| TYPE | YEAR | PROJECT NO. | SHEET NO. |
|---|---|---|---|
| R.O.W. | 2015 | HSIP-106(33) | 19 |
| CONST. | 2017 | HSIP-106(33) | 29 |

S.R. 106 WILLIAMSON CO.

BEGIN STA. 109+00.00
END STA. 110+00.00

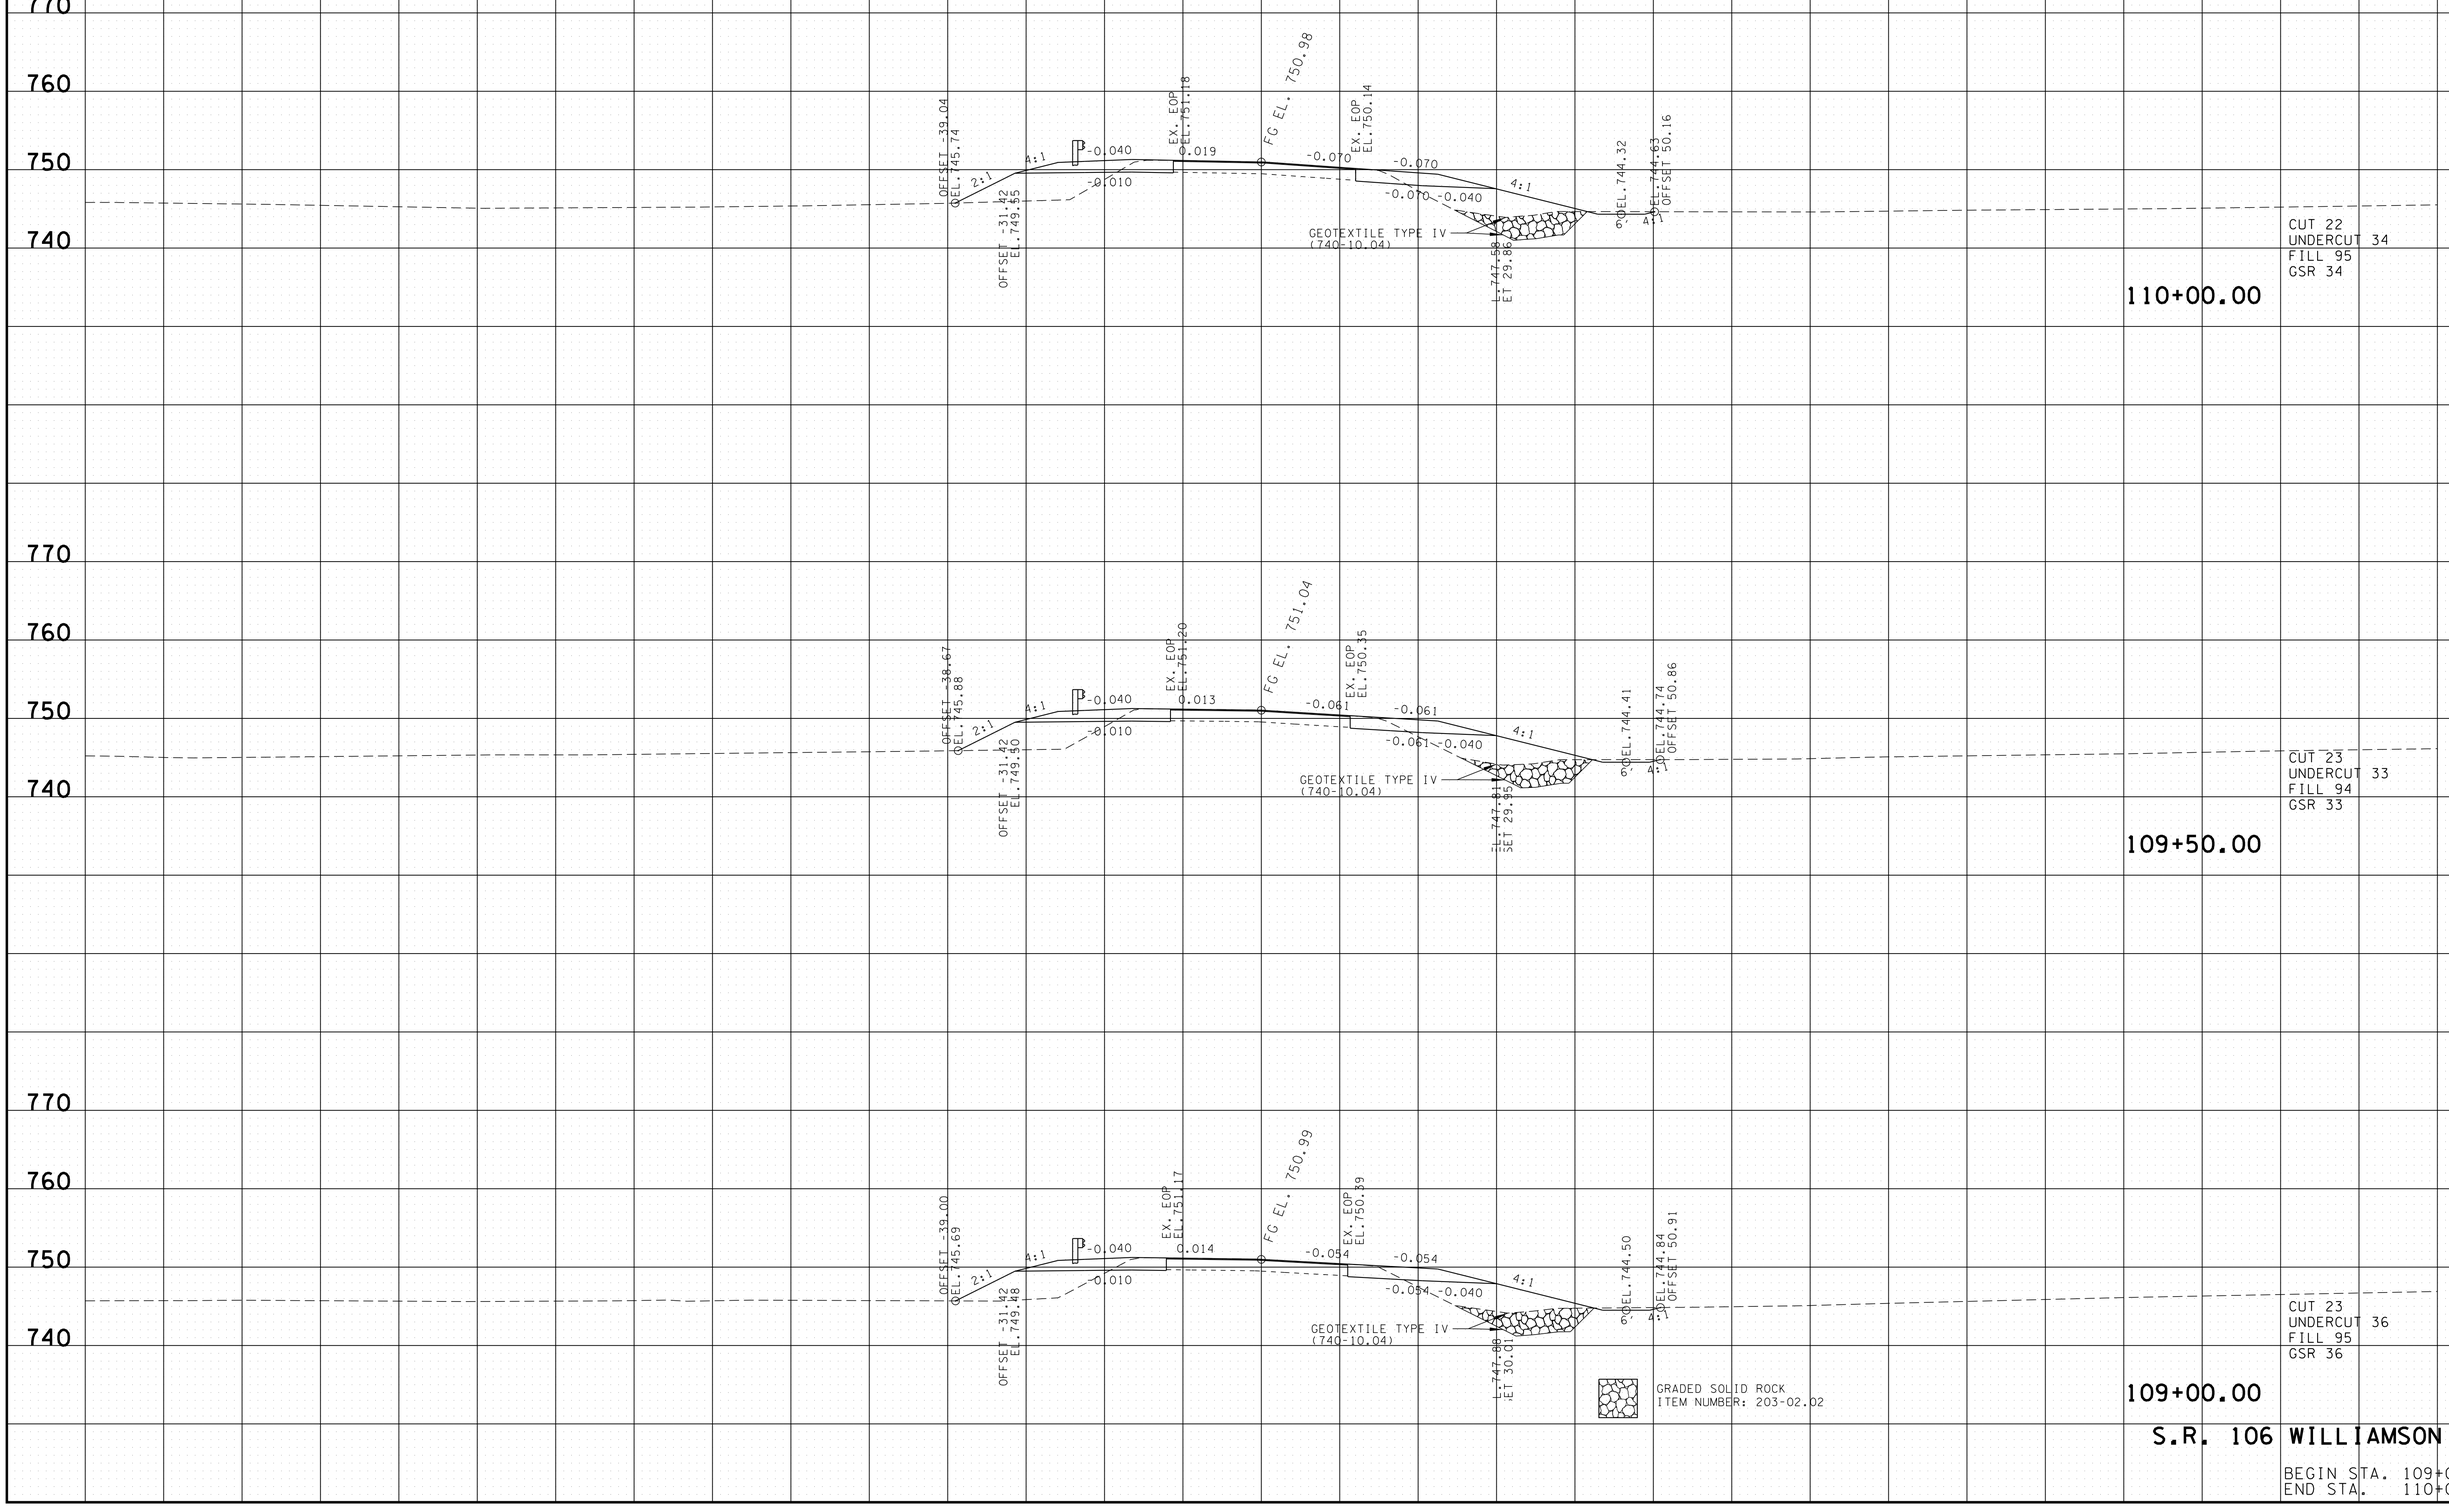
REV. 12-08-16: REMOVED GUARDRAIL, MODIFIED DITCHES, FLATTENED SIDESLOPE FROM 2:1 TO 4:1, AND UPDATED EARTHWORK FROM RT. STA. 106+00 TO STA. 118+50.
